Product Change Notification / LIAL-14RZLJ133

CCB 4159 Final Notice: Implement Microchip Part Aging Policy, Recertification and Combination rules, Labels and Packing Changes for selected Microsemi Field Programmable Gate Array (FPGA) and Mixed Signal and ASIC(MSA) products

CCB 4159
Pre and Post Change Summary
PCN#: LIAL-14RZLJ133

For MSA:

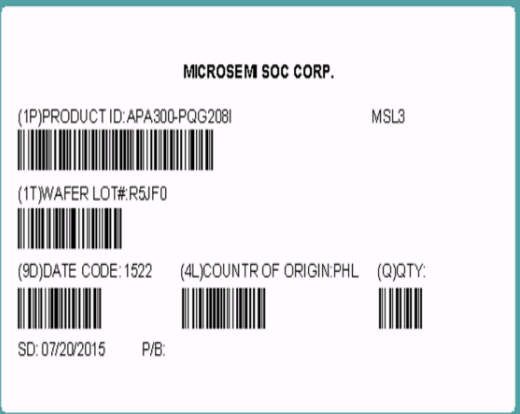
- 1 Device
- 3 Date codes
- No limit to number of production lots follow date code combination rule.
- 1 Assembly Site
- 1 Test Site
- 1 Mask Revision

Moisture Sensitivity Identification label (MSID Label)

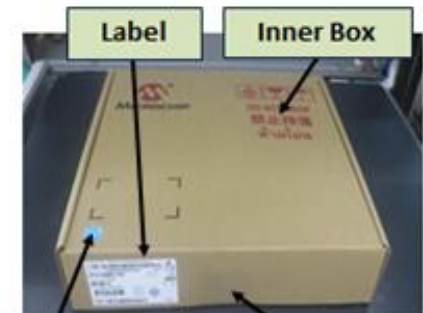
Not apply MSID label on the inner carton.

44L PLCC Tube Drawing

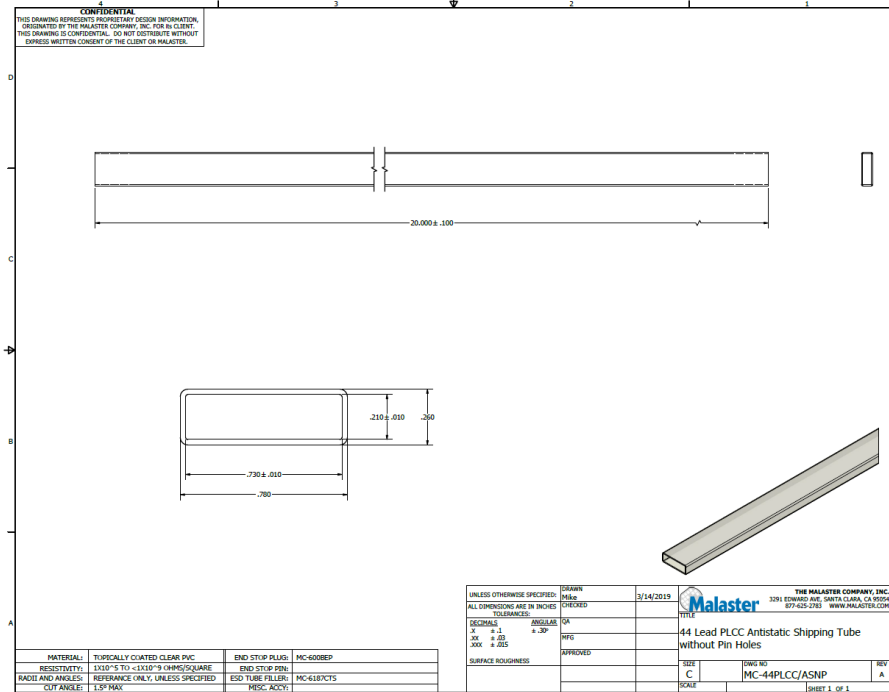
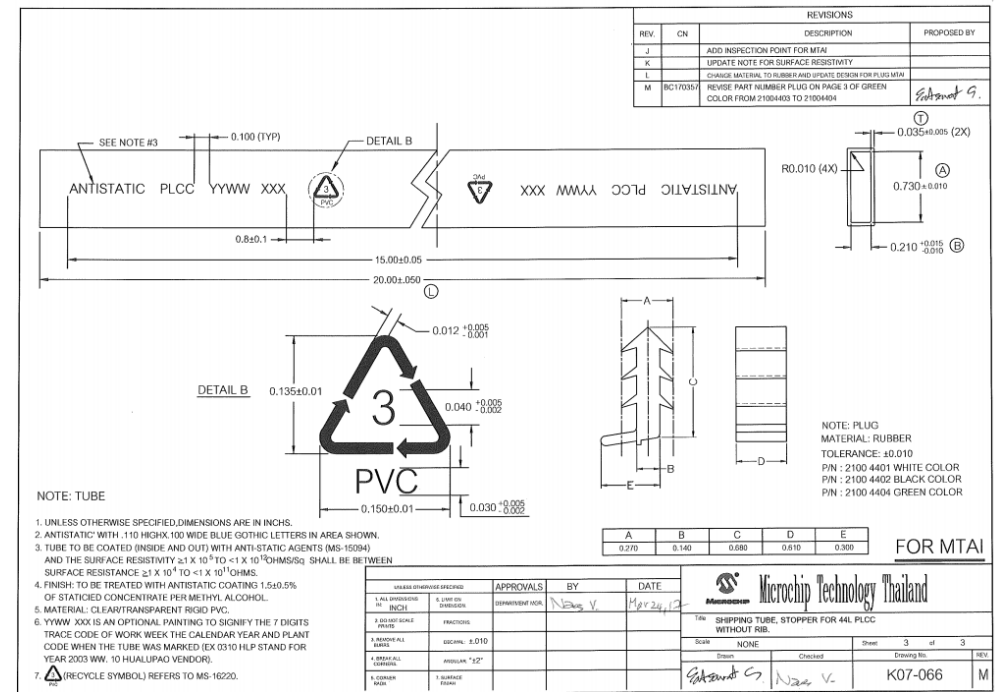
PRE- CHANGE (FPGA (San Jose))

POST CHANGE -(MTAI)

LOCATION	Length (in)	A (in)	B (in)	Thickness (in)	Tube Color	Units/Tube
FPGA	20.00 +/-0.100	0.210 +/-0.010	0.730 +/- 0.010	0.025	Clear	27
MTAI	20.00 +/-0.050	0.210 +0.015/-0.010	0.730 +/-0.010	0.035	Clear	27

68L PLCC Tube Drawing

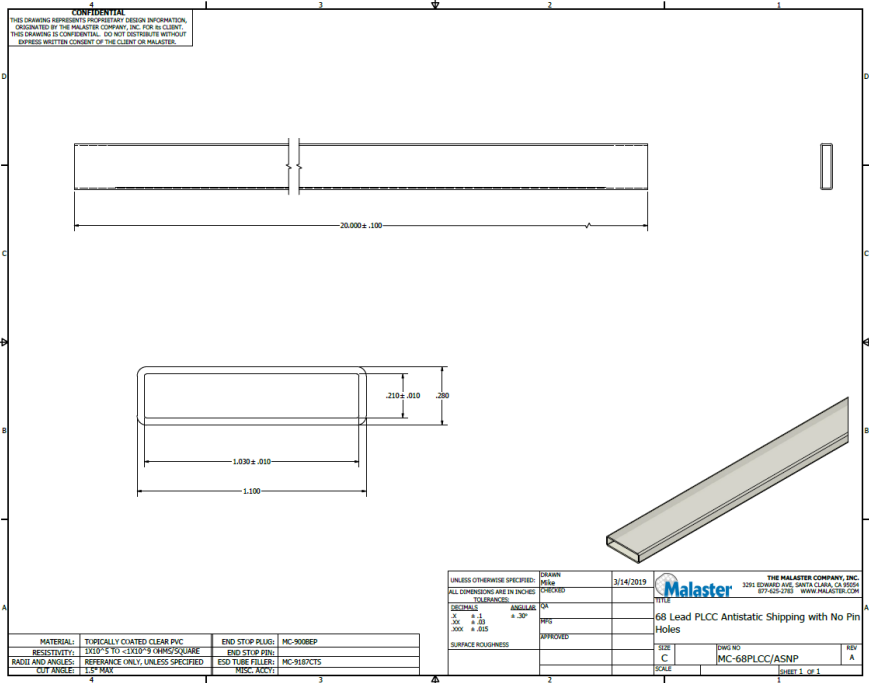
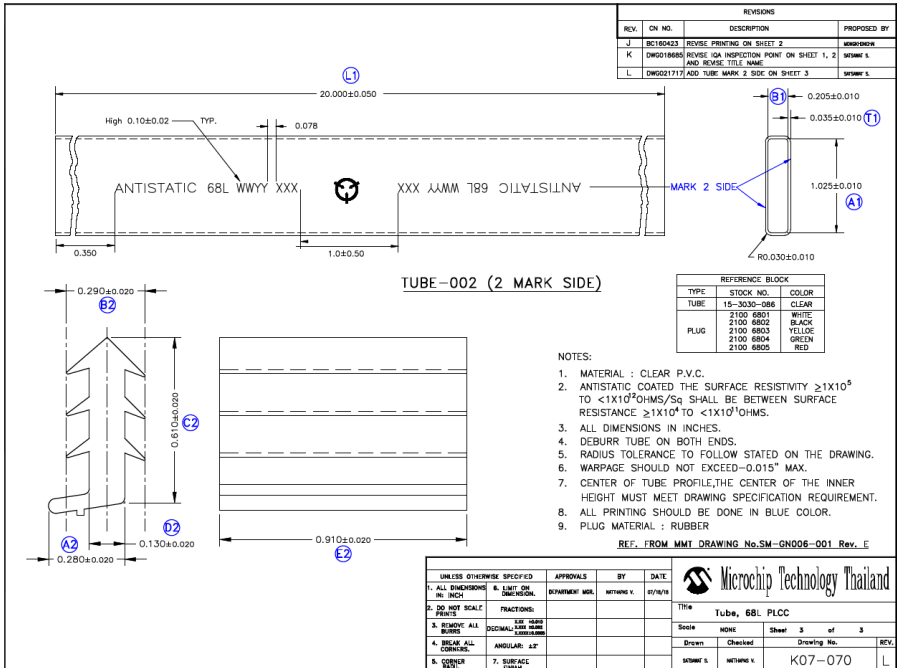
PRE- CHANGE (FPGA (San Jose)

POST CHANGE – (MTAI)

LOCATION	Length (in)	A (in)	B (in)	Thickness (in)	Tube Color	Units/Tube
FPGA	20.00 +/-0.100	0.210 +/-0.010	1.030 +/-0.010	0.035	Clear	19
MTAI	20.00 +/-0.050	0.205 +/-0.010	1.025 +/-0.010	0.035	Clear	19

84L PLCC Tube Drawing

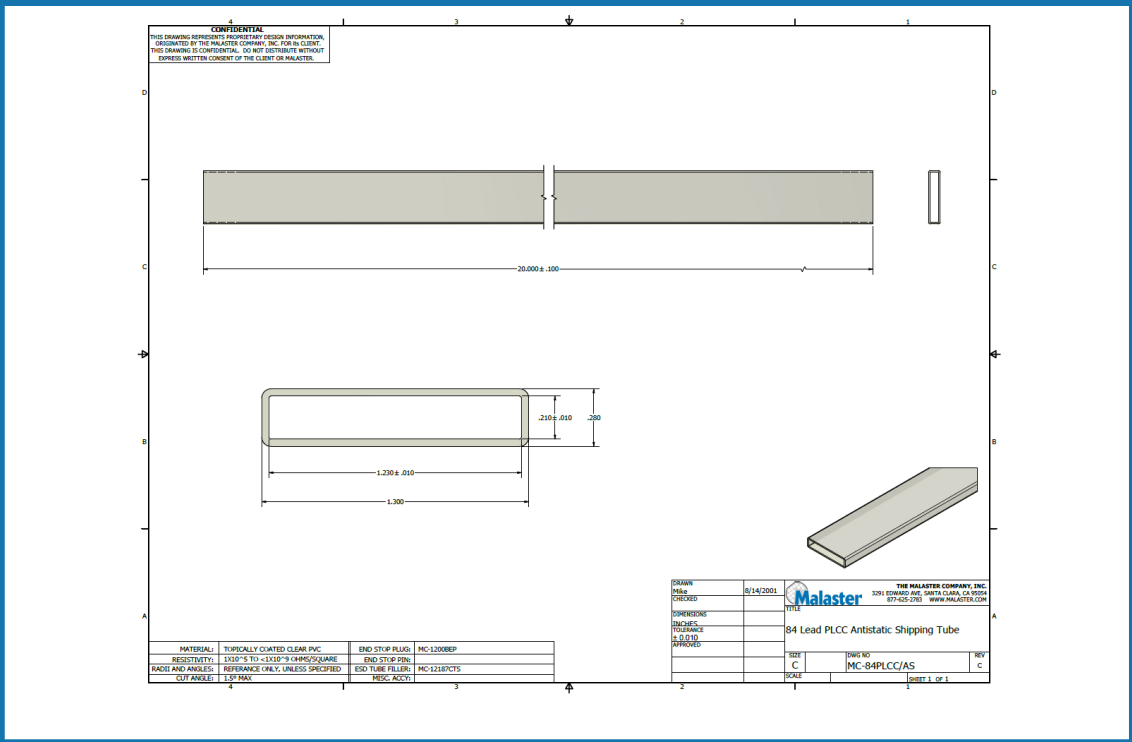
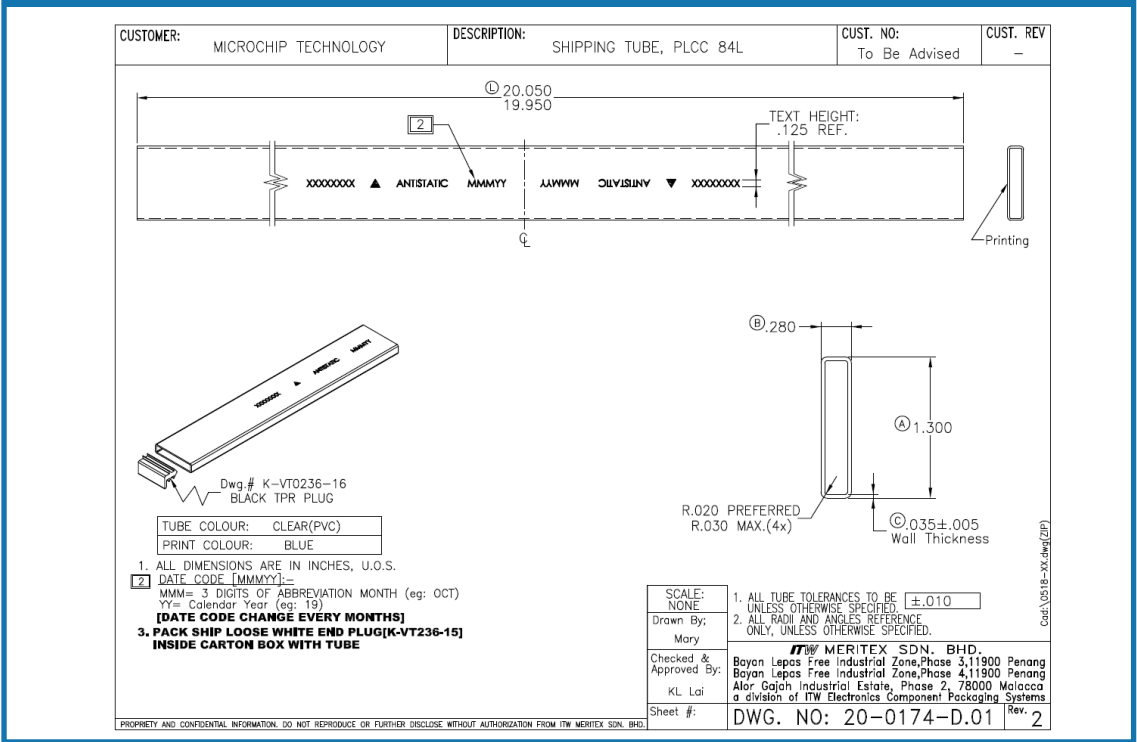
PRE- CHANGE (FPGA (San Jose)

POST CHANGE – (MTAI)

LOCATION	Length (in)	A (in)	B (in)	Thickness (in)	Tube Color	Units/Tube
FPGA	20.00 +/-0.100	0.210 +/-0.010	1.230 +/-0.010	0.035	Clear	16
MTAI	20.00 +/-0.050	0.210 +/- 0.010	1.230 +/-0.010	0.035	Clear	16

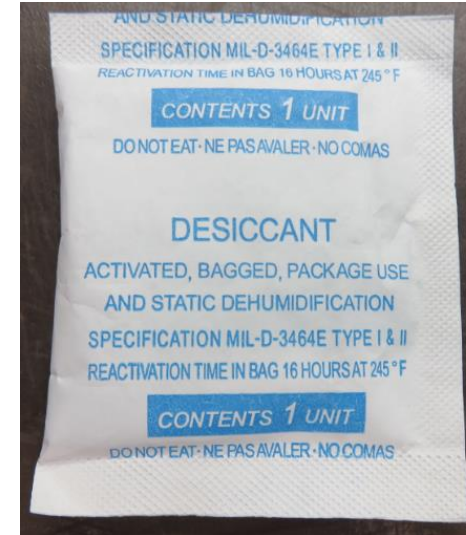
Packing Media	Amount of Desiccant per one MBB
Tray	2 Units (2 Units x 1 pouch)
Tube	2 Units (2 Units x 1 pouch)
13" TnR	2 Units (2 Units x 1 pouch)

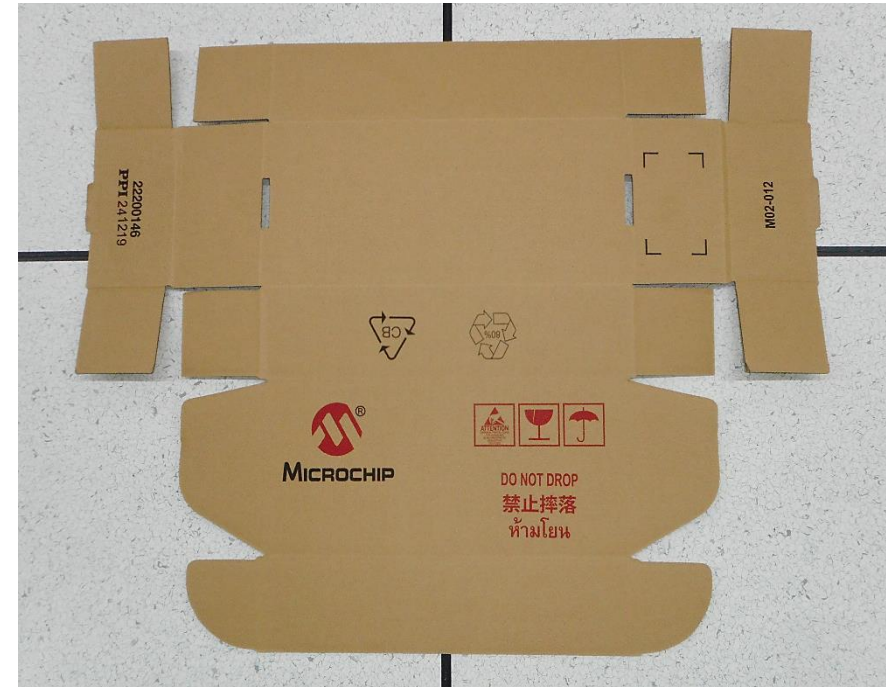
Drawing Number	Dimension (Cm)
QFPI	16.83 x 35.9 x 9.53

Drawing Number	Dimension (Cm)
M02-012	16.2x37.1x8.8

Tray Strapping Method

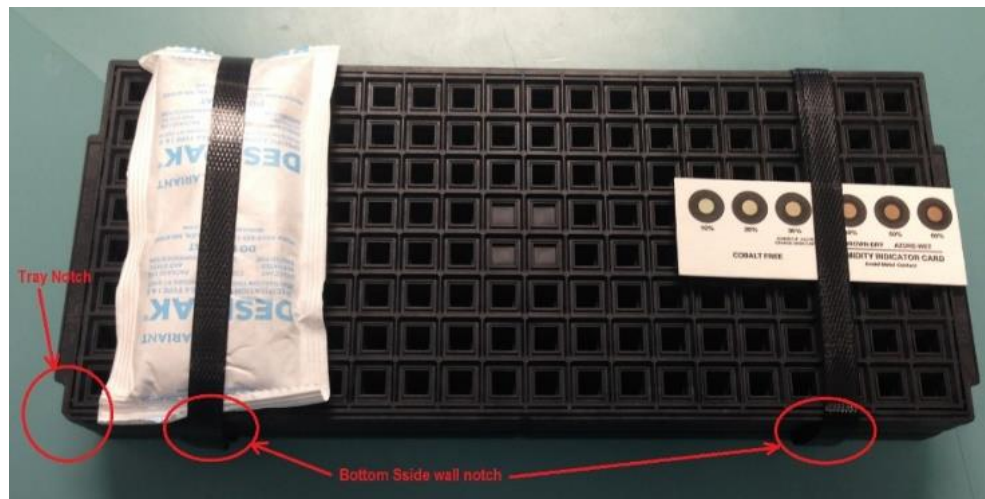
2 width tray strapping

Plug Color

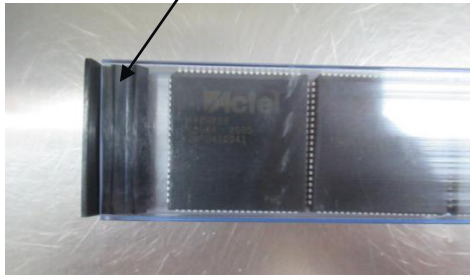
Using Black Plug for both sides
